BIDDING AND CONTRACT REQUIREMENTS
ADDENDUM NUMBER 1

Date: February 11, 2025

Architect's Project Number:
224151.00

Re: **Addendum Number 1 to the bidding documents for:
Moline – Coal Valley School District #40
Browning Field Concessions and Toilet Room Improvements**

PROPOSED SITE AND UTILITY PLAN

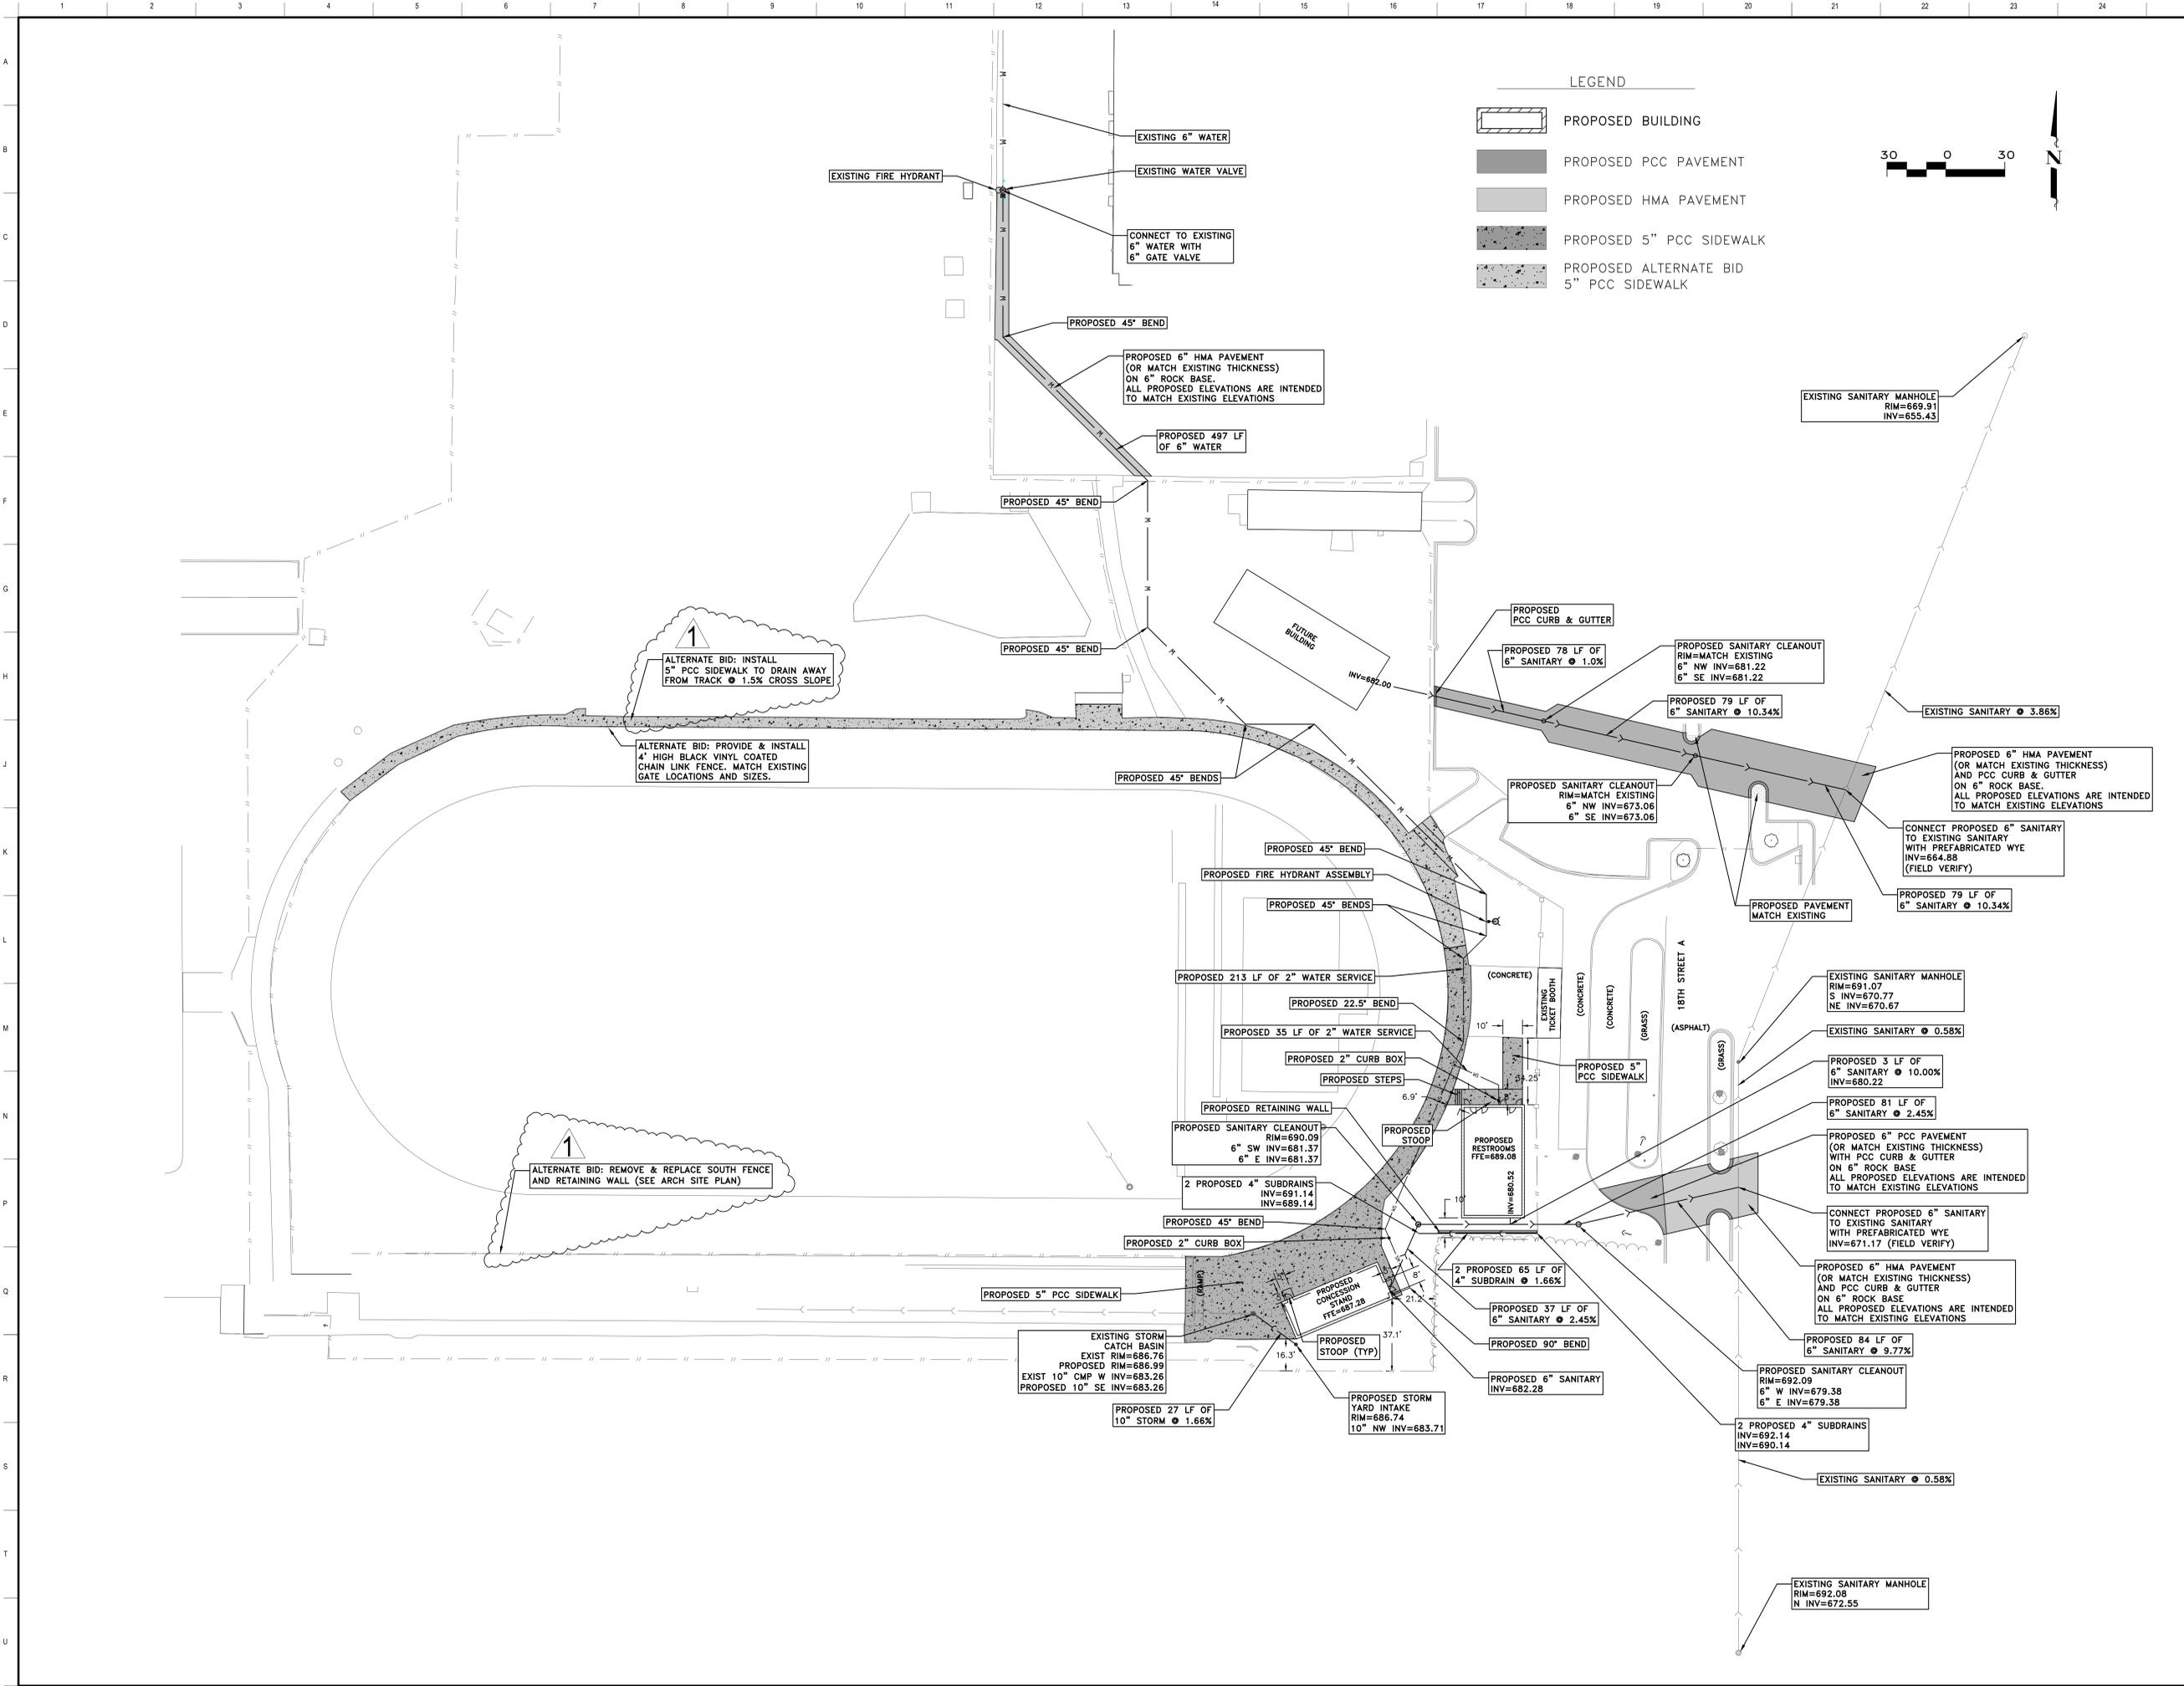
- C. Drawing C-3, titled, PROPOSED SITE AND UTILITY PLAN.
 - 1. REPLACE sheet with attached sheet. Revised notes regarding fence, sidewalk, and retaining wall.

1 FOUNDATION PLAN
1/8" = 1'-0"

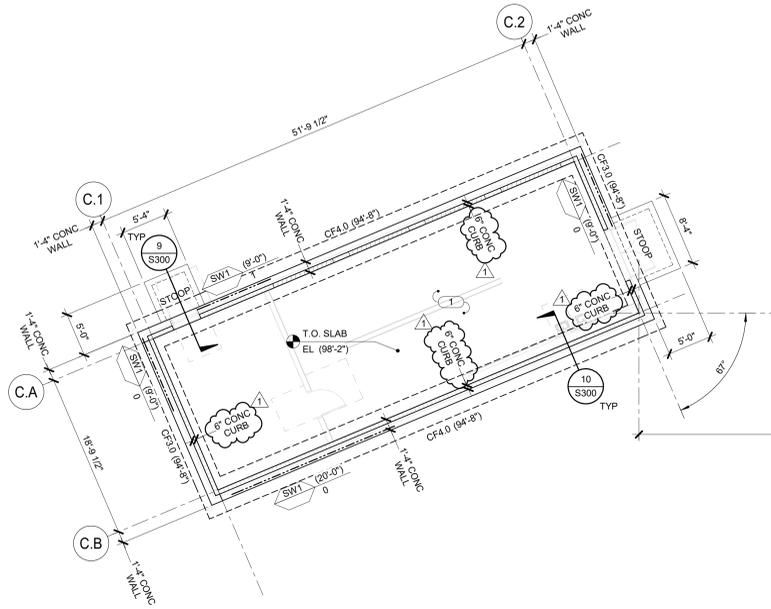
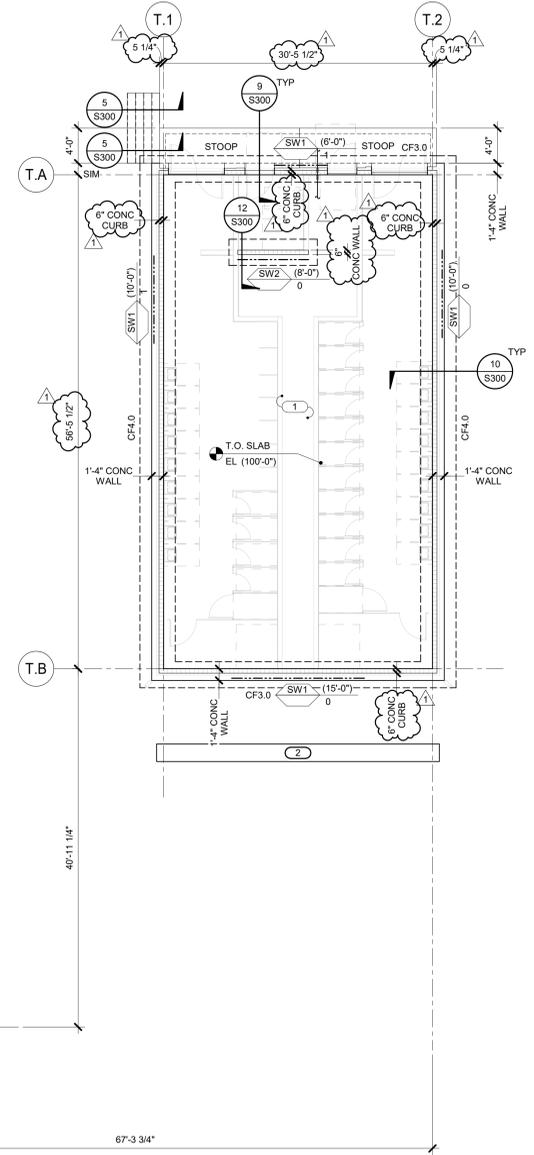
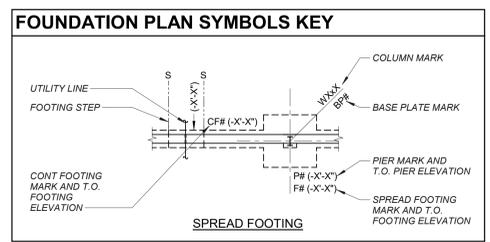
- E. Drawing S100, titled, FOUNDATION PLANS.
 - 1. REVISE Sheet Notes.
 - 2. REVISE Cold Form Shear Wall Schedule.
 - 3. REVISE dimensions.
 - 4. ADD 6" concrete curb.

2 HOLDOWN ANCHORAGE DETAIL
1/2" = 1'-0"
S_Cf-400

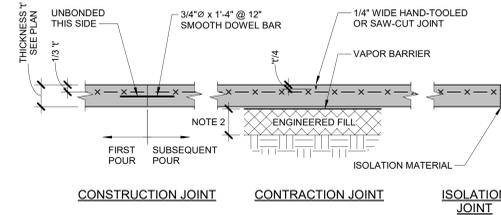
- 1. REVISE holddown in detail 2.
 - 2. REVISE detail 10.
- H. Drawing S400, titled, COLD FORM STEEL FRAMING DETAILS.
 - 1. REVISE detail 10.
- I. Drawing AS001, titled, ARCHITECTURAL SITE PLAN.

1 SITE PLAN
1" = 30'-0"

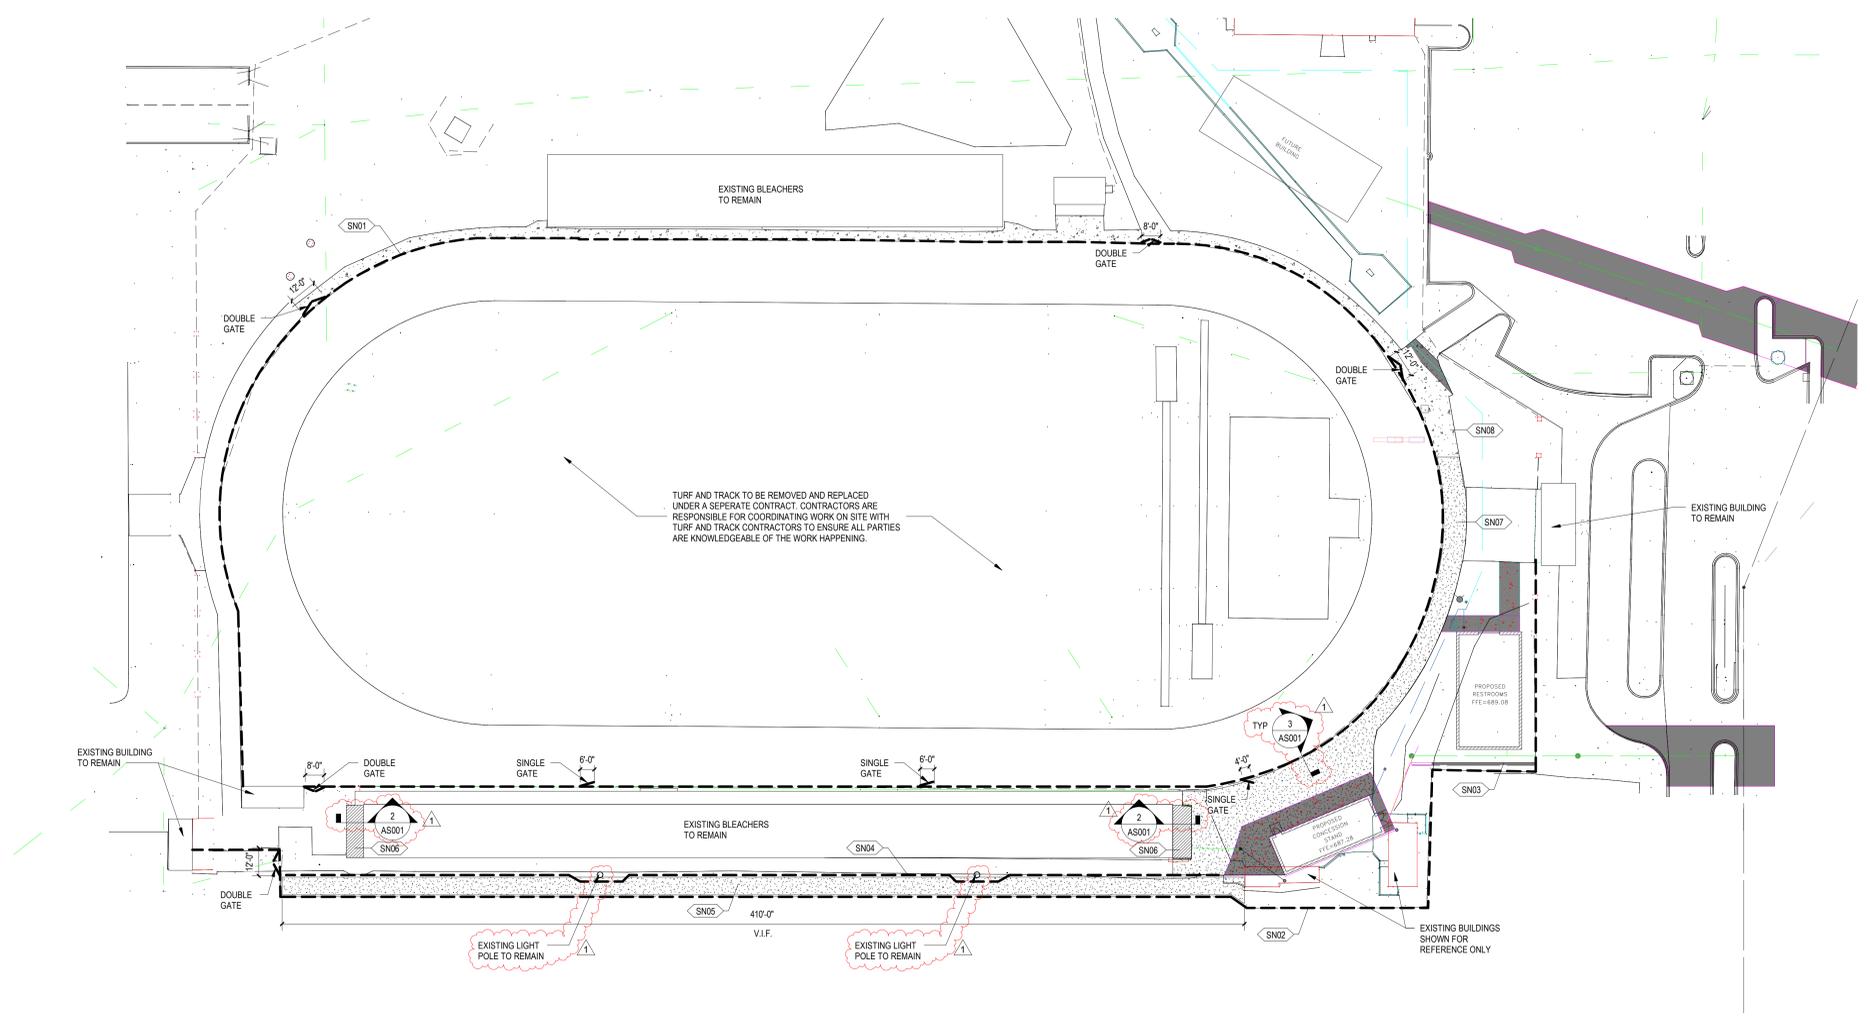
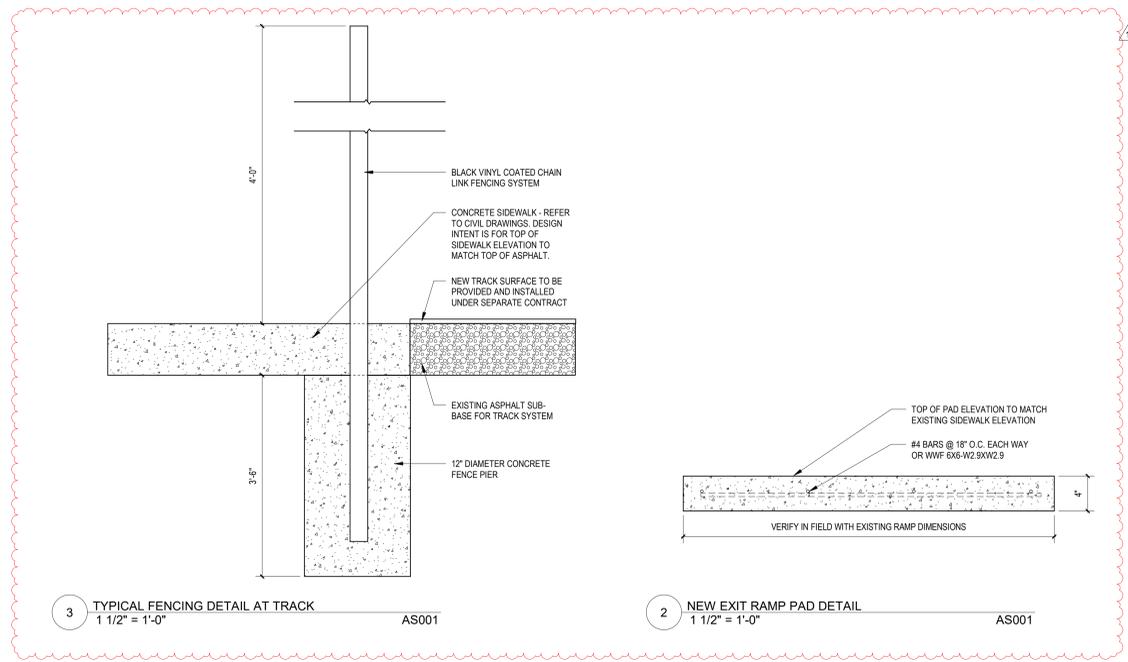
- 1. REPLACE sheet with attached sheet.
- J. Drawing A-101, titled, FIRST FLOOR PLAN
 - 1. REPLACE sheet with attached sheet.
- K. Drawing AF101, titled, FIRST FLOOR FINISH PLAN

2 CONCESSION STAND - FLOOR FINISH PLAN
1/4" = 1'-0"

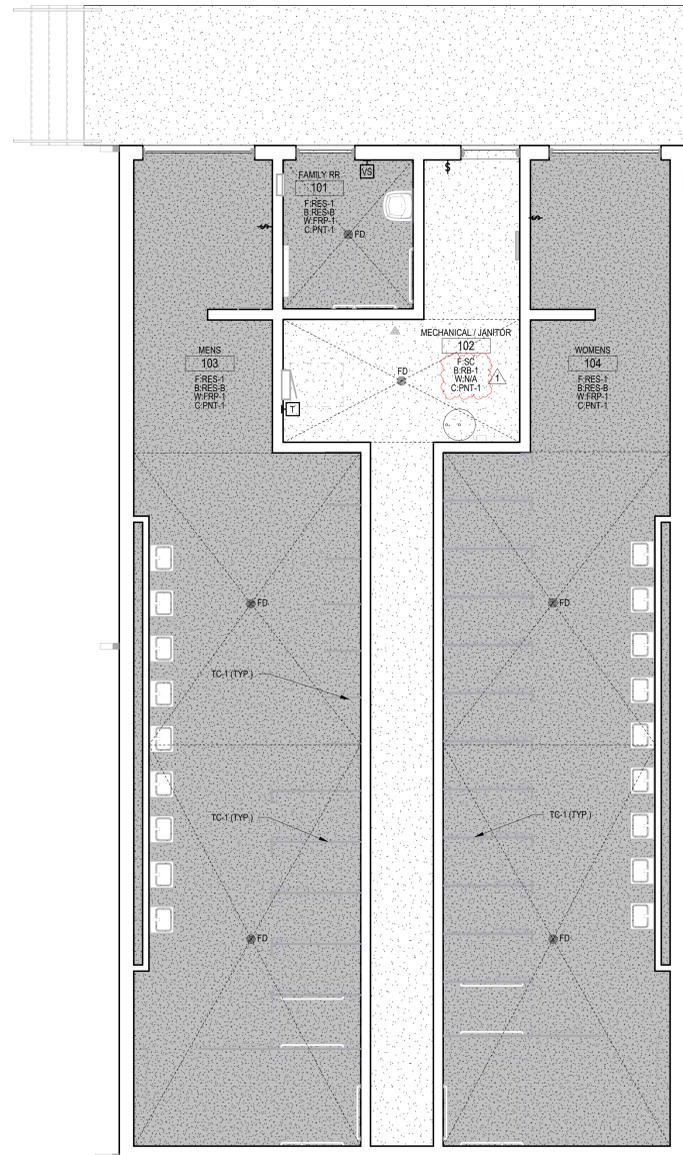
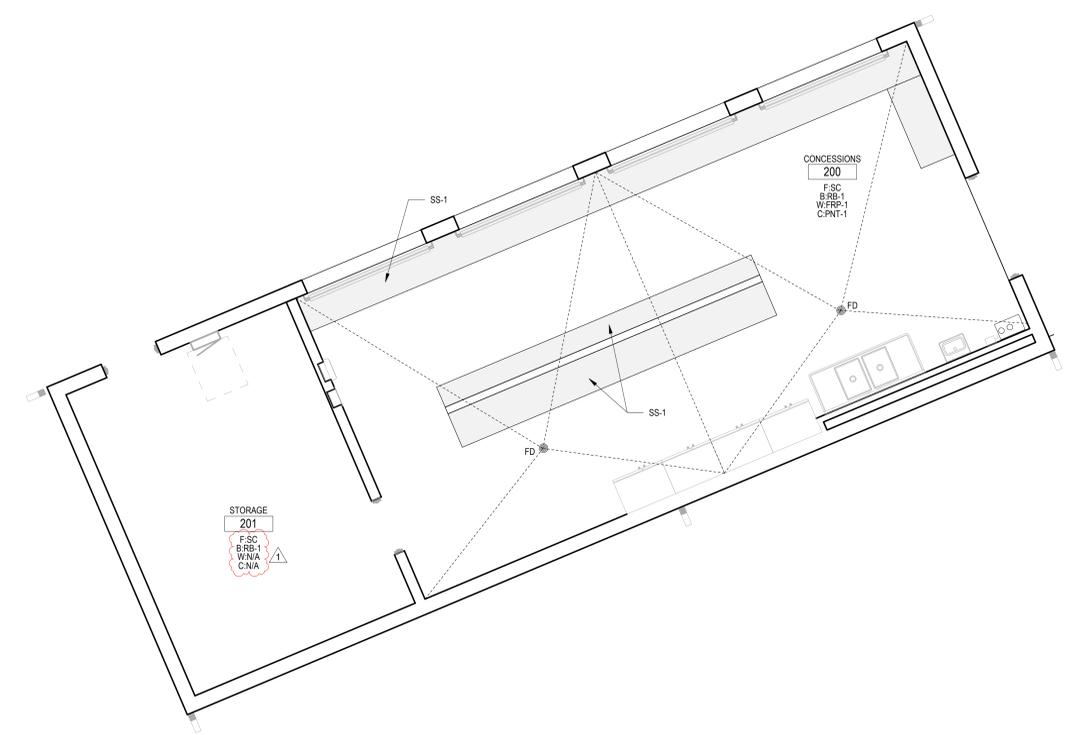
- 1. REPLACE sheet with the attached.
- L. Drawing AC101, titled, FIRST FLOOR REFLECTED CEILING PLAN
 - 1. REPLACE sheet with the attached.
- M. Drawing AR101, titled, ROOF PLAN

1 BUILDING SECTION - CONCESSIONS EAST
1/8" = 1'-0" A-101

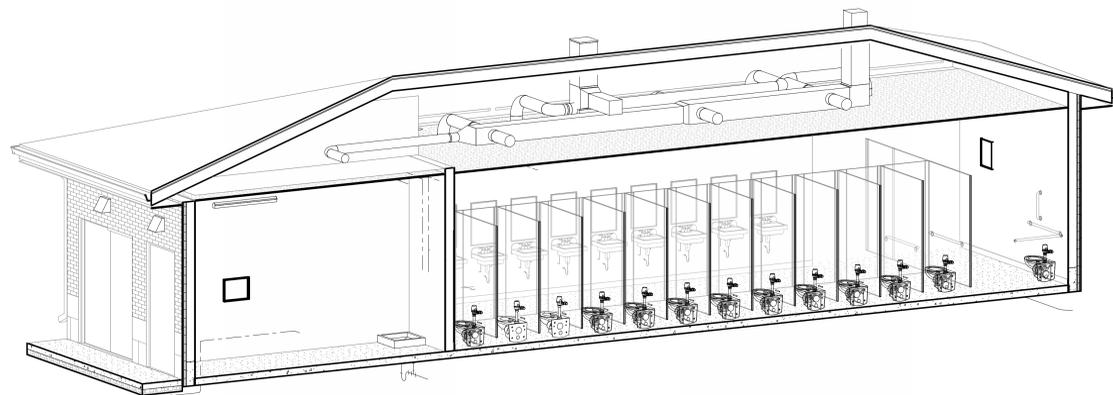
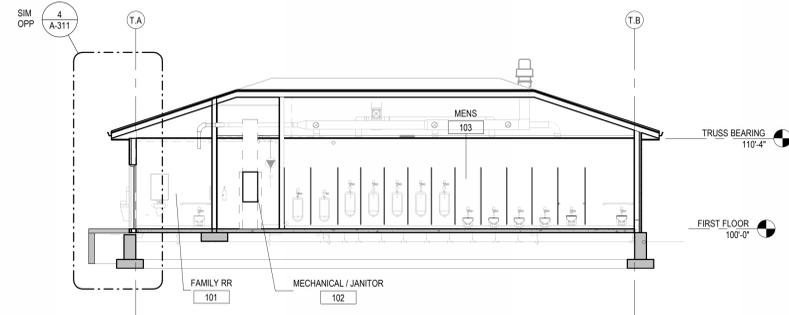
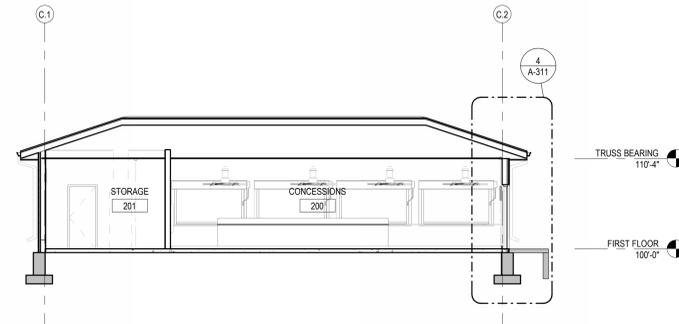
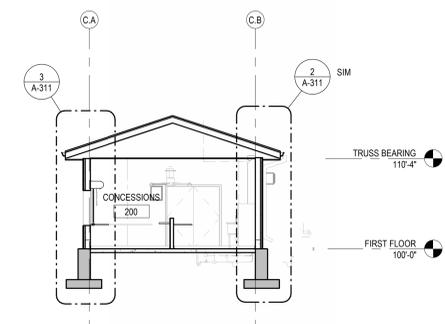
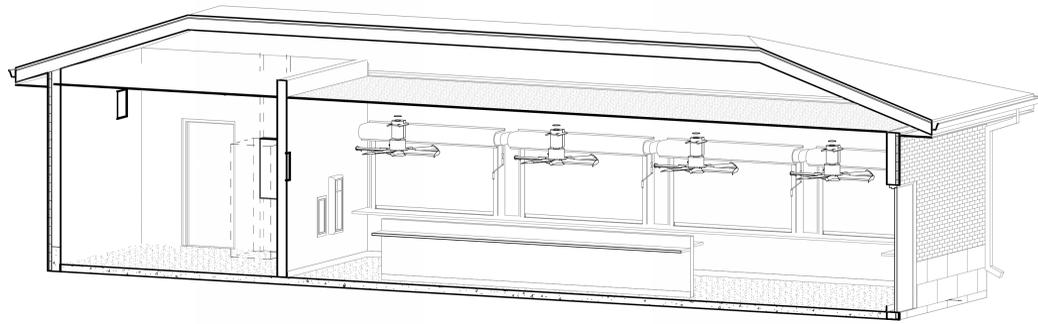
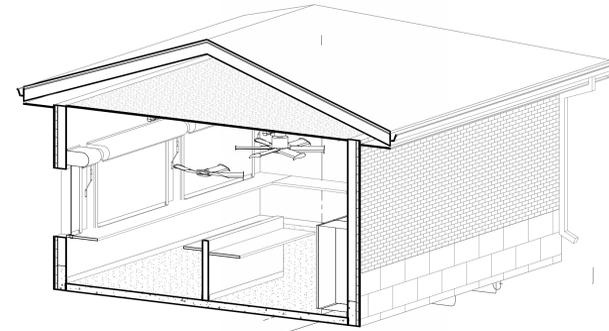
- 1. REPLACE sheet with the attached.
- N. Drawing A-301, titled, BUILDING SECTIONS
 - 1. REPLACE sheet with the attached.
 - 2. Refer to Part 3 - Clarifications section of Addendum 01.

- A. Drawing A-301, titled, BUILDING SECTIONS.
 - 1. Drawing is reissued with graphic updates only, which are that foundations are hidden in axonometric views for clarity. Refer to structural drawings and details for more information on foundation wall design.
- B. Bidding Questions and Responses
 - 1. See attached spreadsheet with question and response list.
